Summary of Amendments to Site Layout Plan Sought under Section 146B

Project  
**SECTION 146B AMENDMENT TO APPROVED COOLINABACKY 400KV / 110KV SUBSTATION**  
(Class: Voluntary Development Project)  
Title  
Site Layout Plan - Section 146B Amendment

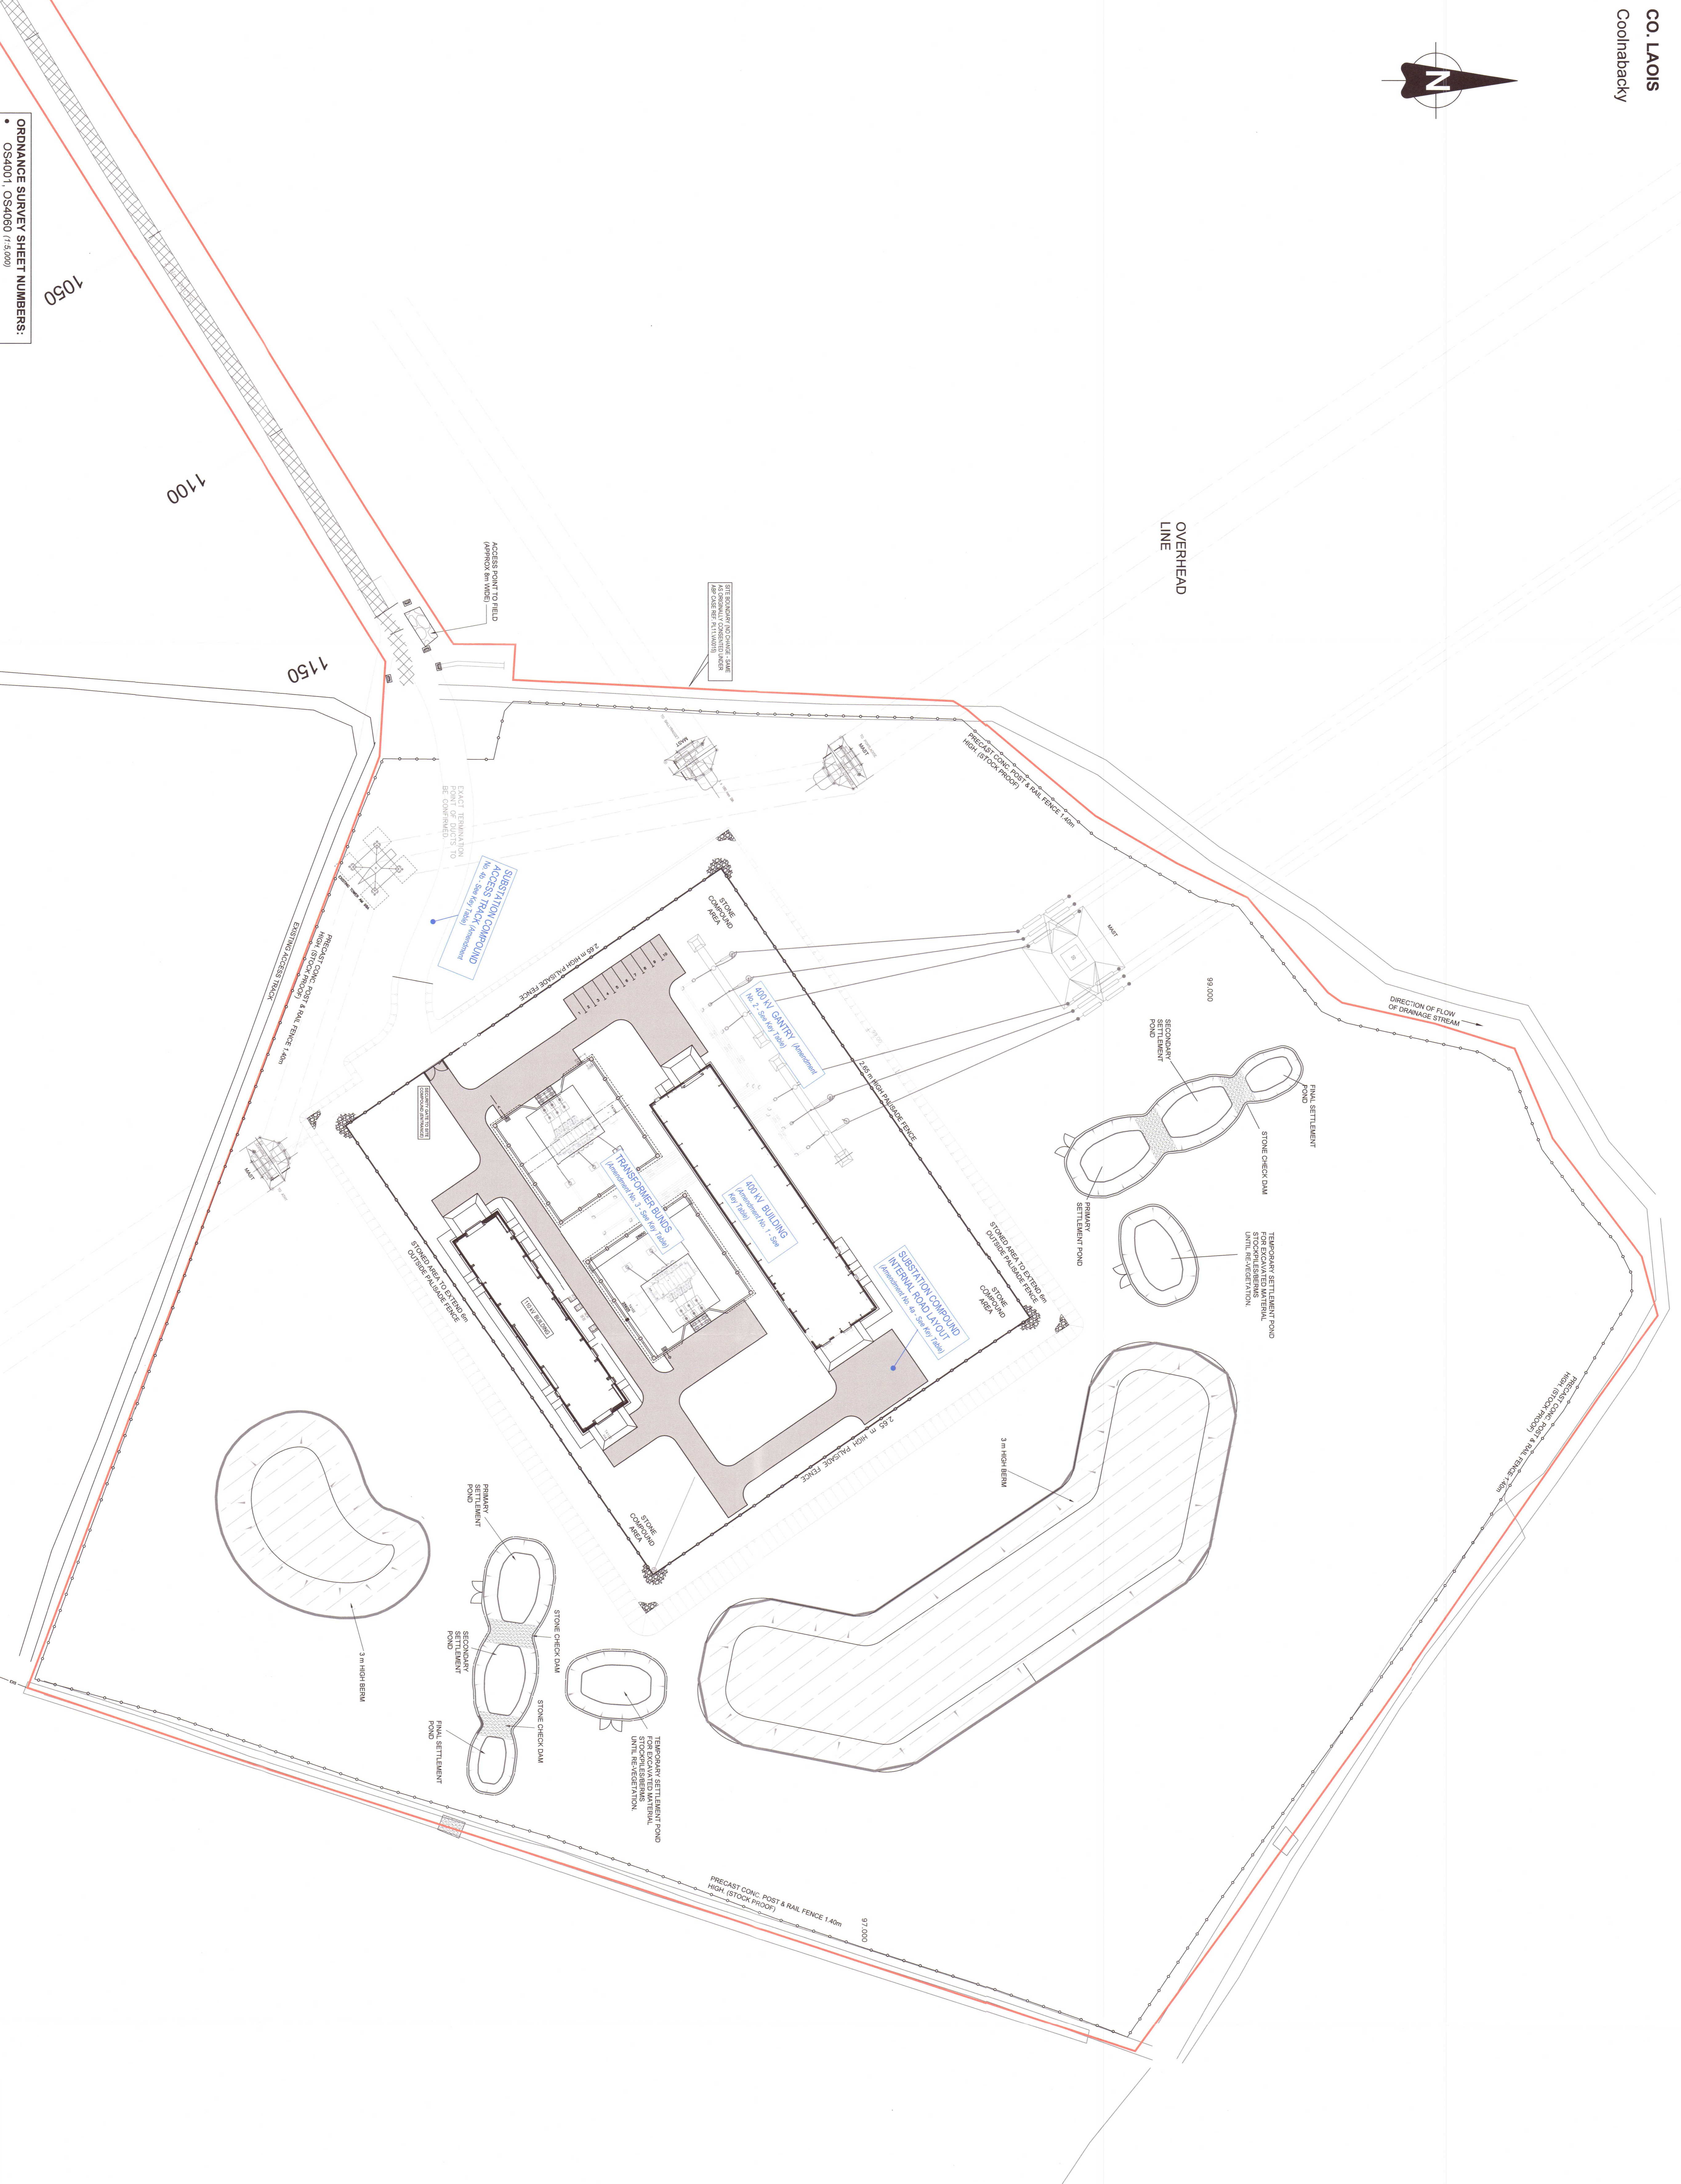
Amendment No.	Description of Amendments
1	400V Substation Building: Repositioned 2 metres north of its originally consented location (ABP Case Ref. PL11/VA0015). No change in size or height.
2	400V Gantry: Slightly shifted southwest from the originally consented position (ABP Case Ref. PL11/VA0015). No change in height.
3	Transformer Bundles: Two sandstone transformer bunds (each c. 25.15m x 25.53m x 1.2m) replacing the originally consented bunds (each c. 50.5m x 11.15m x 1.2m) (ABP Case Ref. PL11/VA0015).
4a	Substation Compound Internal Road Layout: Minor reconfiguration of the internal road layout to accommodate the above amendments. They will accommodate 200% of the transfer oil capacity.
4b	Substation Compound Access Track: Slight realignment of the originally consented access track (ABP Case Ref. PL11/VA0015).
5	Substation Drainage Network: Minor adjustments to the surface water collection network in line with the revised internal road layout.
